UNITED STATES PATENT AND TRADEMARK OFFICE

APPLICATION NO.	FILING DATE	FIRST NAMED INVENTOR	ATTORNEY DOCKET NO.	CONFIRMATION NO.
10/634,918	08/06/2003	Kazuyuki Uenoyama	037083.48851D4	6475
23911	7590	05/31/2006	EXAMINER	
CROWELL & MORING LLP INTELLECTUAL PROPERTY GROUP P.O. BOX 14300 WASHINGTON, DC 20044-4300			MCMAHON, MARGUERITE J	
		ART UNIT	PAPER NUMBER	3747

Office Action Summary	Application No.	Applicant(s)	
	10/634,918	UENOYAMA ET AL.	
	Examiner	Art Unit	
	Marguerite J. McMahon	3747

DETAILED ACTION

Fig.1

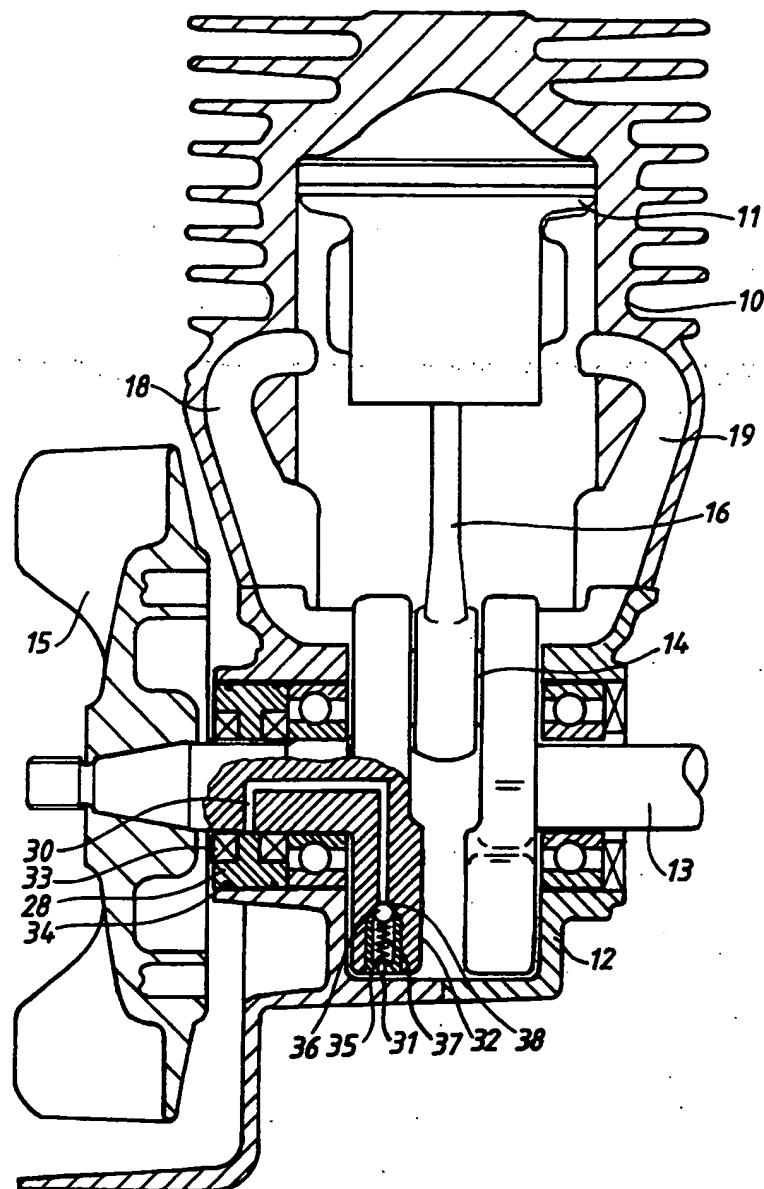
plane, which is at a right angle to a crankshaft and contains an axis of the cylinder, wherein the front and rear portions are attached to each other by fasteners 11, wherein a crankcase scavenging passage is formed inside a wall in each of the front and rear crankcase portions symmetrically with respect to said crankcase separating plane, the front and rear portion scavenging passages being formed above the crankshaft bearing part, wherein the scavenging passage has a top opening above a cylinder mounting surface and an outlet at the side of the crankcase with a microscopic gap between the opening and the end surface of the crank webs 15A, wherein each of the front and rear portions includes a scavenging passage which provides fluid communication between the scavenging passage of the cylinder and a crank chamber of the crankcase so as to allow a fuel-air mixture to flow from the crank chamber to the scavenging ports, wherein the cylinder is attached by fasteners to a mounting surface on the crankcase (see column 2, lines 67-69), and wherein the scavenging passages of each of the cylinder and the crankcase are arranged symmetrically along a front to rear plane of the engine. Tenney shows everything except the crankshaft bearing part in each front and rear portion being formed within a diameter of the cylinder. Doragrip teaches that it is old in the art to form the crankshaft bearing parts within a diameter of the cylinder (see Figure 1 on next page).

It would have been obvious to one having ordinary skill in the art to modify Tenney by locating the bearings such that they are within the diameter of the cylinder, since this is conventional.
